UNITED STATES PATENT AND TRADEMARK OFFICE

APPLICATION NO.	FILING DATE	FIRST NAMED INVENTOR	ATTORNEY DOCKET NO.	CONFIRMATION NO.
10/776,176	02/12/2004	Michel Couture	16626-2us PTN/df	3079
7590	03/02/2007		EXAMINER	
MICHEL COUTURE 360 TERRASSE ROBILLARD SAINT-ANDRE'-D'ARGENTEUIL QUEBEC, J0V 1X0 CANADA			HAGEMAN, MARK	
			ART UNIT	PAPER NUMBER
			3653	
SHORTENED STATUTORY PERIOD OF RESPONSE		MAIL DATE	DELIVERY MODE	
3 MONTHS		03/02/2007	PAPER

Office Action Summary	Application No.	Applicant(s)	
	10/776,176	COUTURE, MICHEL	
	Examiner Mark Hageman	Art Unit 3653

DETAILED ACTION

Fig. 1

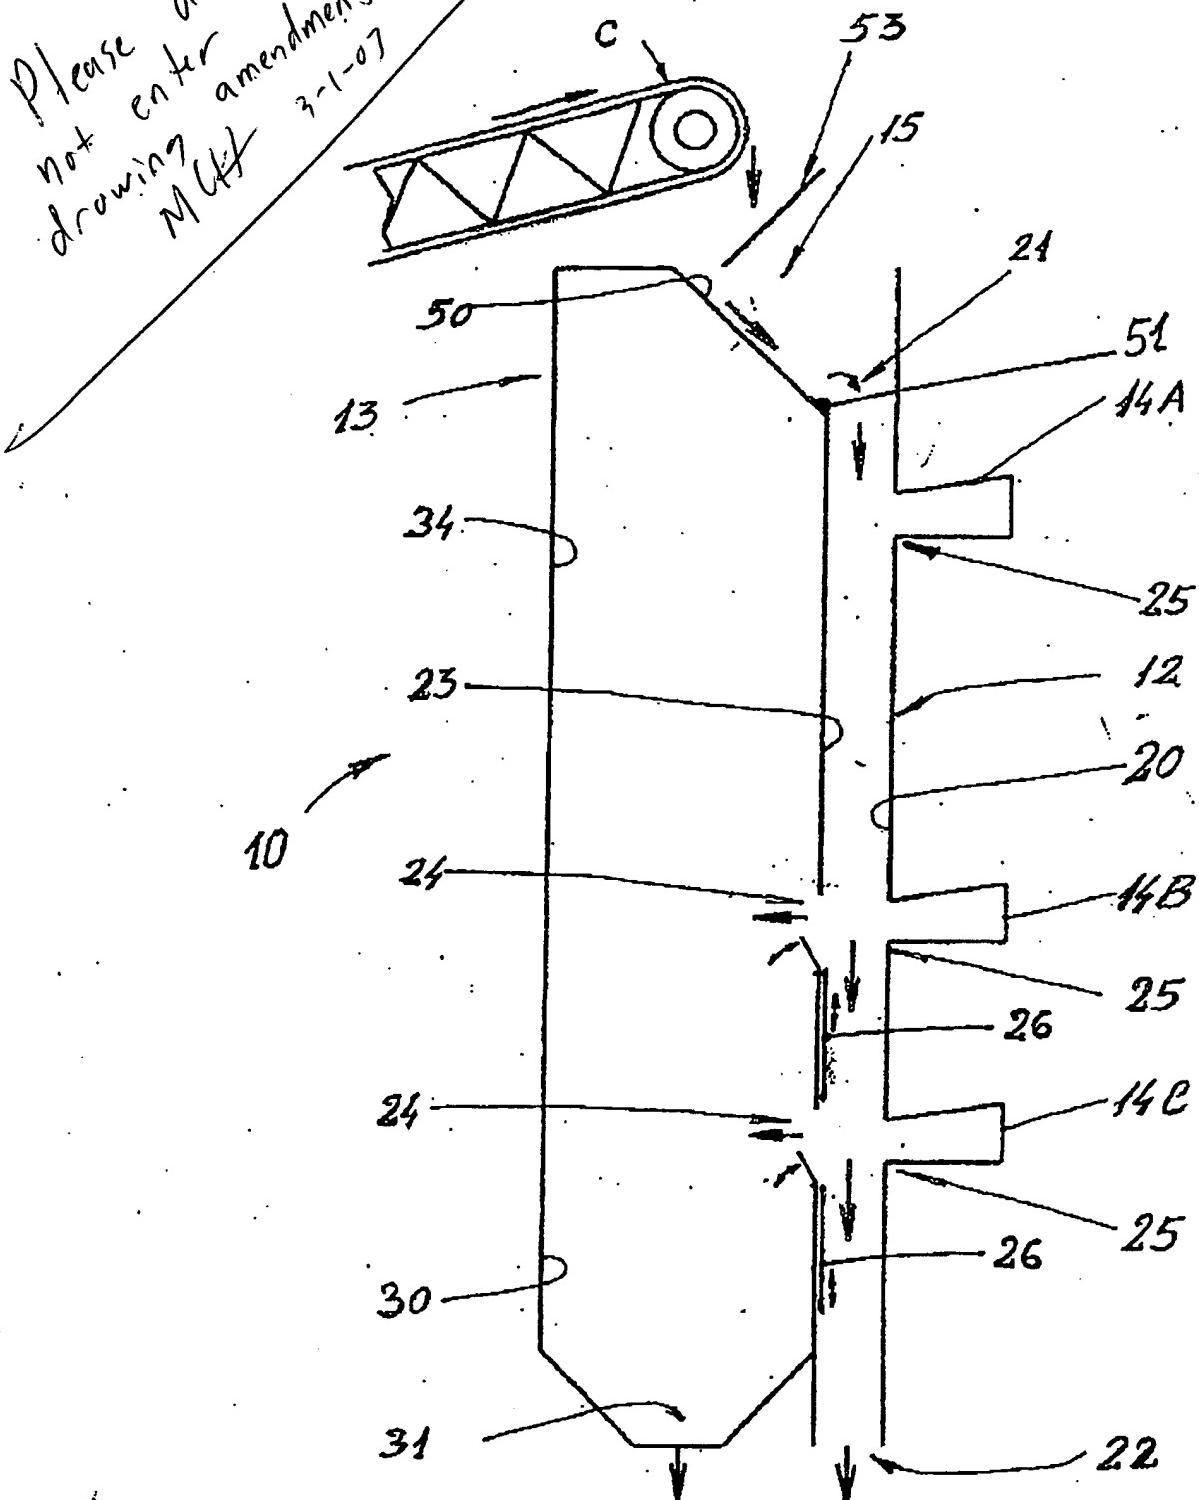
2. The drawing amendment filed 2-22-2007 has not been entered as it introduces new matter. Specifically figure 11 adds structure not supported by the original specification. Examiner acknowledges paragraph 39 as set forth by the applicant regarding figure 11 but maintains that figure 11 includes structure that was not supported by the original specification. Details are present in proposed figure 11 that were not presented in the original specification.

Please do
not enter
drawing
Mkt
amendment
3-1-07
